To DISTRIBUTION	From G.J. Gauck	Page 1 of 1
Project Title/Work Order CLOSED OUT TANK 241-SY-101 DACS SYSTEM CHANGE REQUESTS #301-400.		Date February 21, 1995
		EDT No. 610852
		ECN No.

Document Title: CLOSED OUT TANK 241-SY-101 DACS SYSTEM CHANGE
REQUEST #301-400

This document provides a record closed out System Change Request #301-400 used during the development of the 241-SY-101 Hydrogen Mitigation Project Data Acquisition Control System.

HYDROGEN MITIGATION TEST PROJECT
System Change Request Status

CR No.: 307

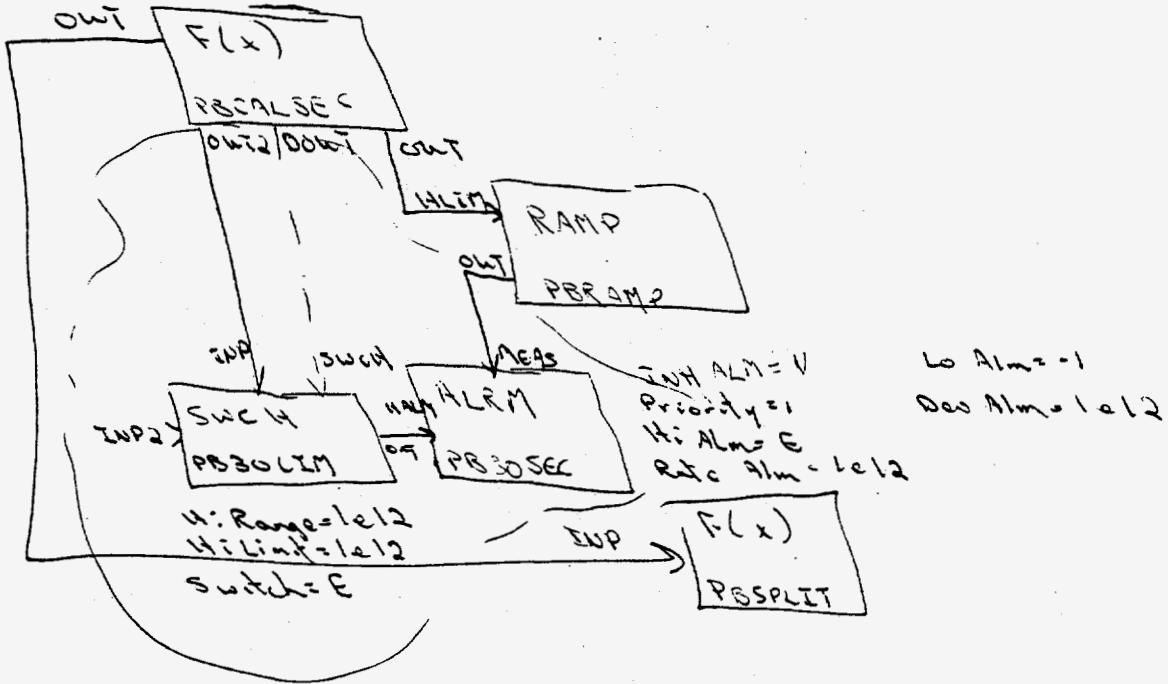
4. SUBMITTER'S PRIORITY: <u>13</u> 1=Critical 2=High 3=Medium 4=Low			
	5. SYSTEM NAME/TITLE: <u>Simplify Phase B 30 Sec Alarm</u>			
	6. DESCRIPTION OF CHANGE: <input type="checkbox"/> See Attached <u>Implement 30 sec alarm for Phase B the same as for Pump Bump, eliminating Report & Recipe Code.</u>

Add the following strategy blocks:

Delete strategy blocks ALMON, 30SECSAT, SIDS9ALM, TURNOFF.

Tank 241-SY-101 Strain Gauges

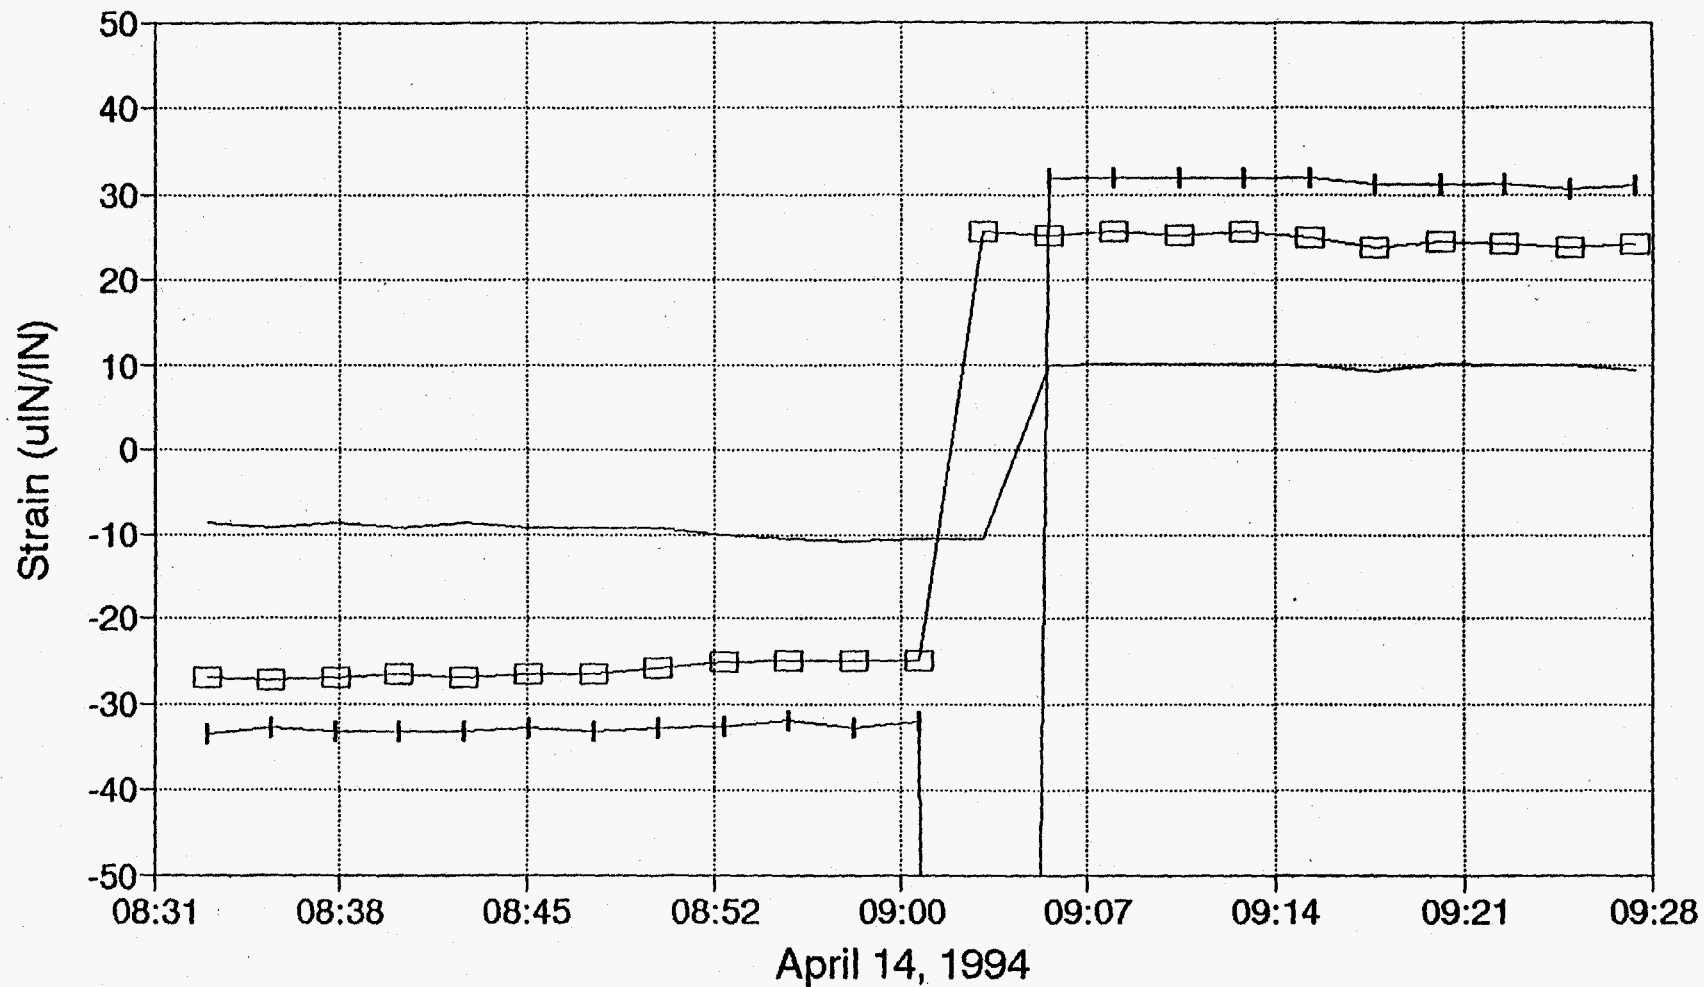
C	SCR	TITLE	DISPOSITION				CHANGE INSTALLED	CHANGE VERIFIED	ATP REQUIRED/ COMPLETE
			APPROVE	REJECT	DEFER	CANCEL			
C	317	Riser 17C T/C elevation correction	3-8-94				3-16-94	3-16-94	N
C	318	VDTT 1B Strain Signal Inversion Drawings changed under Phase 2 Patch Panel	3-8-94				4-14-94	4-14-94	N
C	319	Test / DACS Phase Current Reading Change	3-8-94				3-16-94	3-16-94	N
C	320	OLD72HR display time span (extend to display six hours of data across defined screen)	3-15-94				3-16-94	3-16-94	N
C	321	Cleanup all DACS computer disk files	3-15-94				5-3-94	5-4-94	N
C	322	Obsolete user task files	3-22-94				3-29-94	3-30-94	N
C	323	Remove Unused Computer Cards (Station 1, slot 10 and Station 4, slot 10)	3-22-94				3-31-94	3-31-94	N
C	324	Install/Remove temporary datalogger for tank bottom thermocouple.	3-22-94				6-1-94	6-1-94	Y ATP-069 C
C	325	Removal of CAMS unit	4-5-94		3-30-94		4-5-94	4-19-94	N
C	326	Provide key macros for Jet Penetration	3-30-94				3-30-94	3-30-94	N

SCR 342

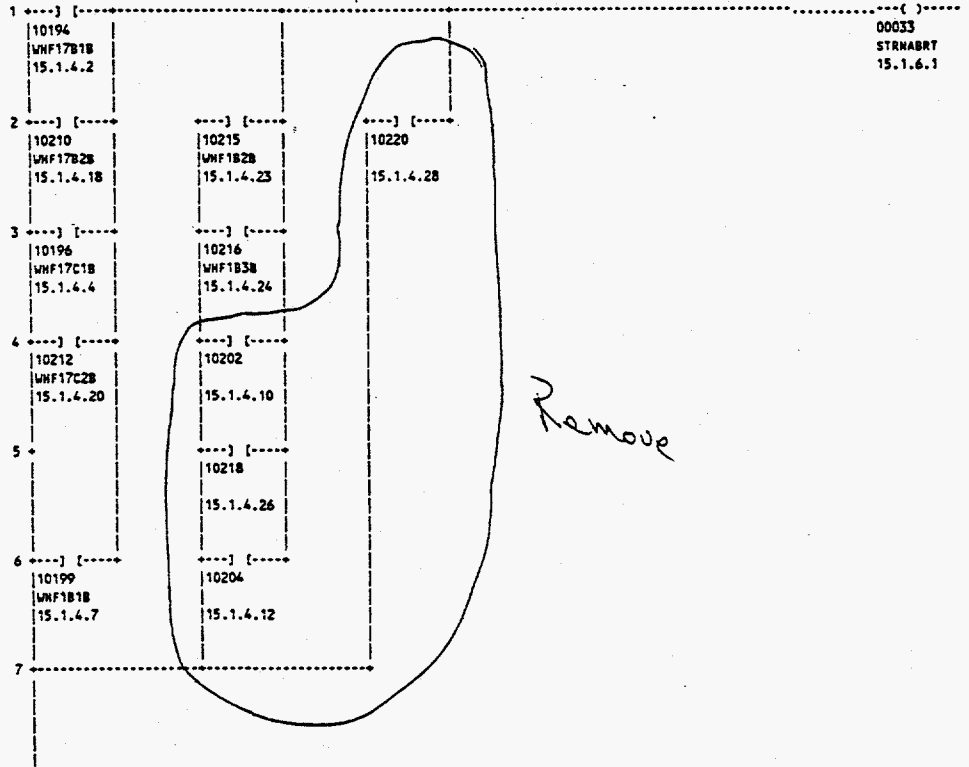
C	341	Remove obsolete WIR14A01, WIR14A02, and WIR14A03 tags	5-3-94						N
C	342	Remove unused inputs to composite aborts (for STRNABRT abort coil #00033)	5-3-94				12-13-94	12-13-94	Y ATP-082 C

create composite aborts
